SITE DEVELOPMENT PLAN

60 VILLA LOUISA ROAD, LLC 60 VILLA LOUISA ROAD - BOLTON, CT

EXISTING CONDITIONS PLAN
A-2 BOUNDARY SURVEY / T-3 TOPOGRAPHY SURVEY
PREPARED FOR
60 VILLA LOUISA ROAD LLC
60 VILLA LOUISA ROAD BOLTON, CT

COMMENT RESPONSE SUMMARY

OVERALL SITE LAYOUT
PREPARED FOR
60 VILLA LOUISA ROAD LLC
60 VILLA LOUISA ROAD, BOLTON, CT

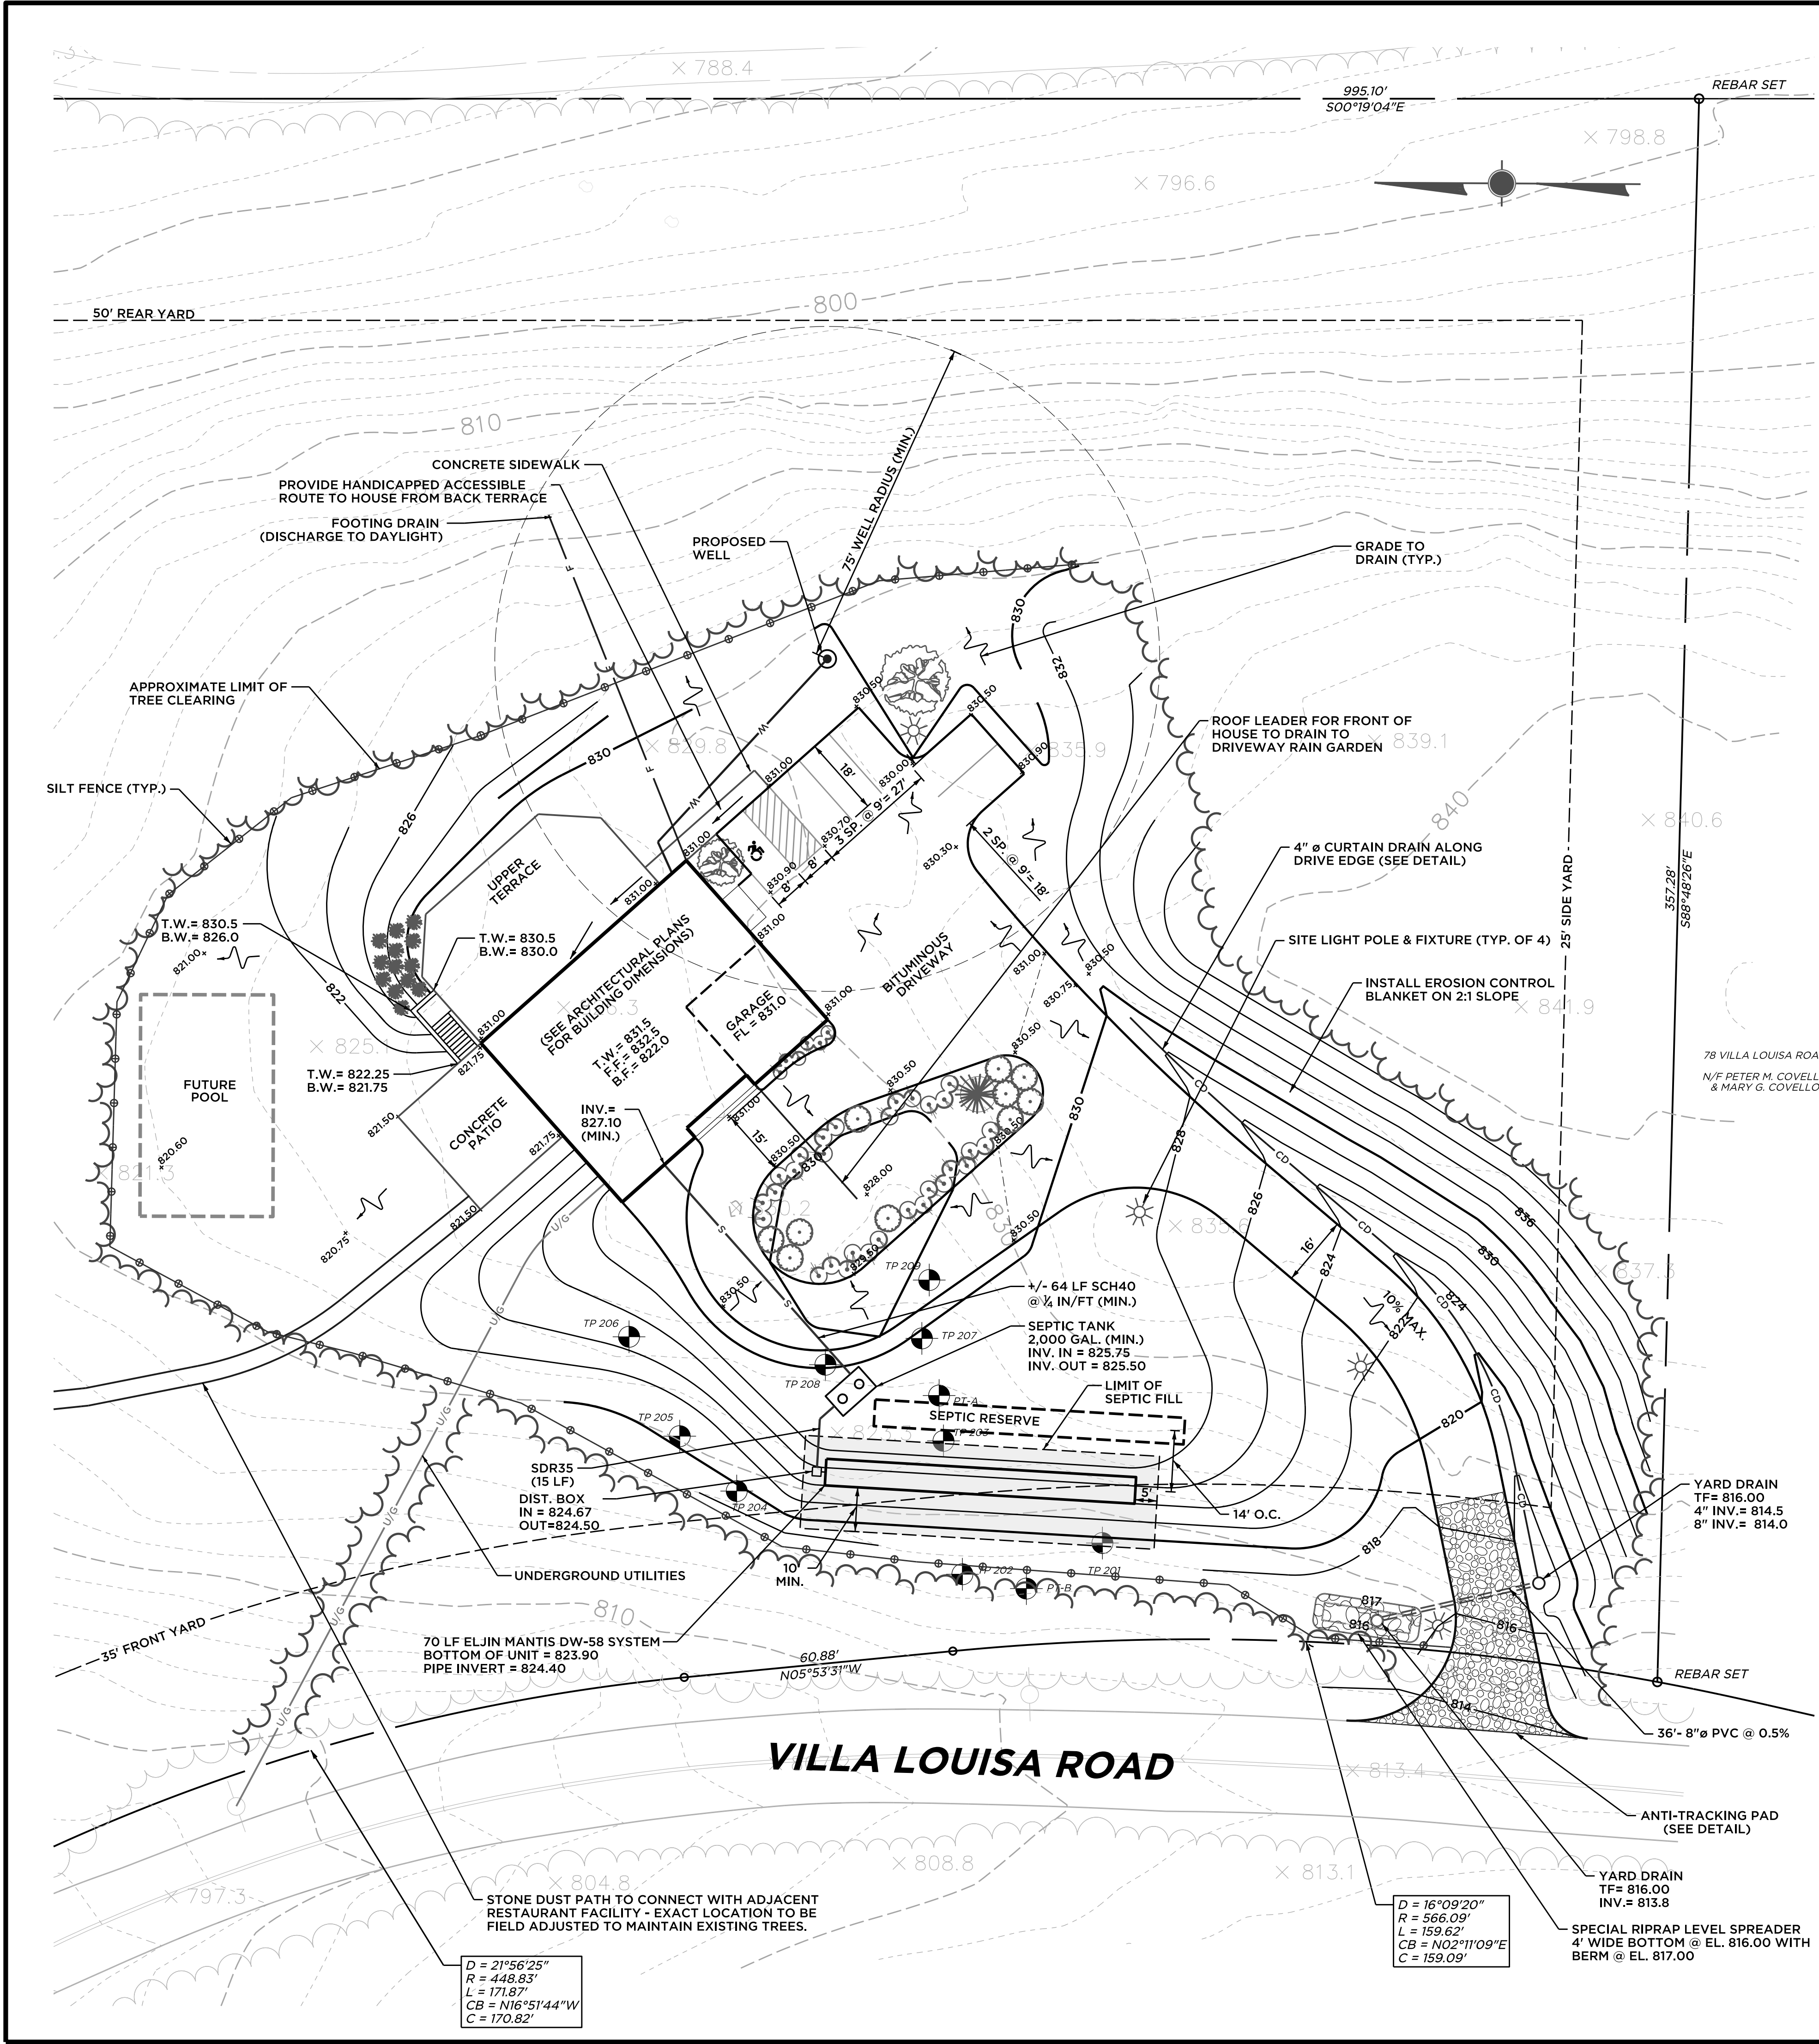
Joe and I just looked at Villa Louisa Rd- The north facing sight line does not appear to be correct 1) vehicle reference is too far back in the driveway and possibly the bank on the opposite side of the road needs to be lowered.

RESPONSE: The sight line and distances were determined based on the location of the driver's eye in the driveway (minor road) at 15' back from the edge of the road in accordance with the CT DOT Highway Design Manual. The height of the driver's eye is at 3.5 feet above grade of drive (818.5+/-) and the height of the object in the road is at 3.5 feet above road grade (797.5+/-). A profile of the existing grade along the line of

sight to the north has been added to sheet 2 of 4. The actual sight distance is not measured along the sight line but along the path of the vehicle in the roadway.

CONSTRUCTION NOTES
PREPARED FOR
60 VILLA LOUISA ROAD LLC
60 VILLA LOUISA ROAD, BOLTON, CT

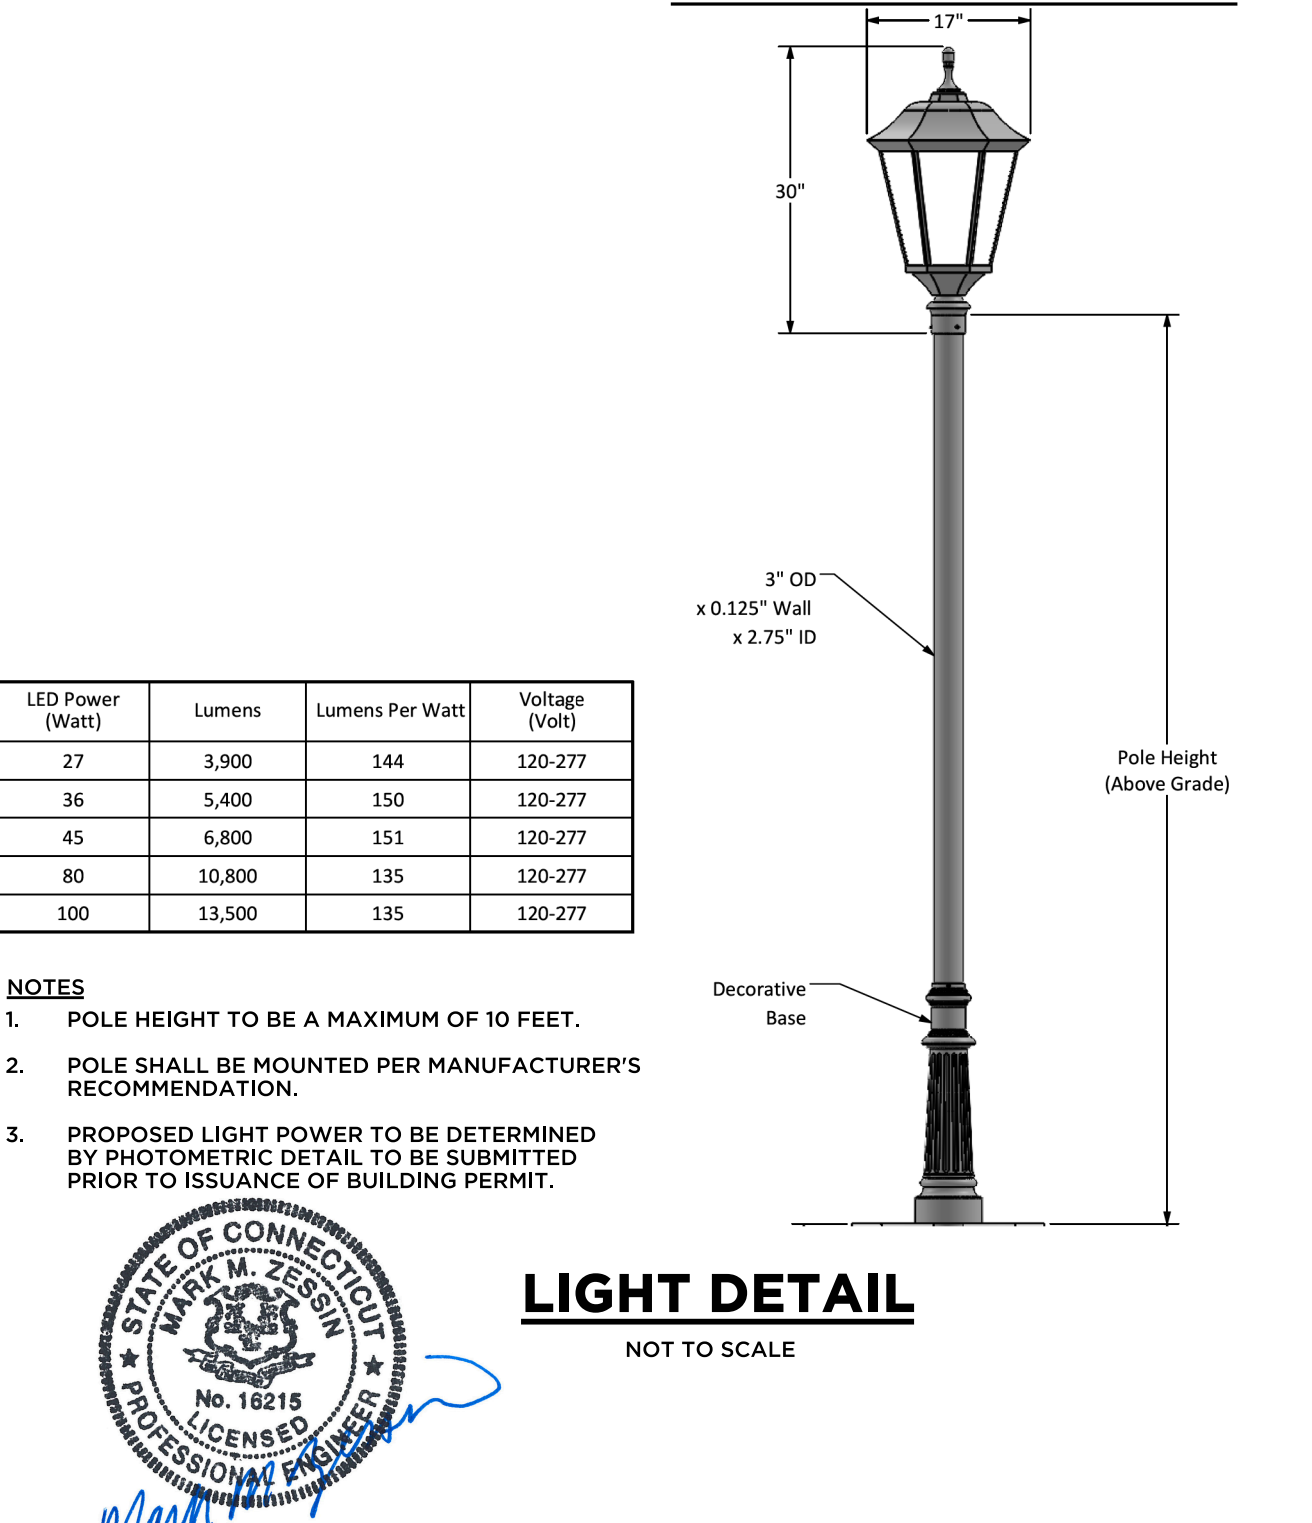
1. Sheet 4 item 8 indicates a private water supply. The property is currently regulated as a public water supply by CTDPH. The proposed use is as a Bed and Breakfast. It is indeterminate if the proposed use will be considered a private or public supply pending the requested CTDPH review.

2. The well permit for a private supply will likely require an exception under Section 19-13-B51m(b) from CTDPH.
RESPONSE: See response for #1.
3. Site development notes should indicate that the new well construction may proceed only after any site blasting to remove ledge has been completed.

RESPONSE: The applicant/owner has completed and submitted a public water supply screening form to CTDPH regarding the proposed additional well on the property and will continue to follow up for feedback.

RESPONSE: This note was added to plan sheet 4 of 4.
4. The design flow is listed as 6 Br, however the Parking Table lists 3 Br dwelling and 2 Br B&B. ELA is listed as a 6 BR at 742.5 SQ FT.
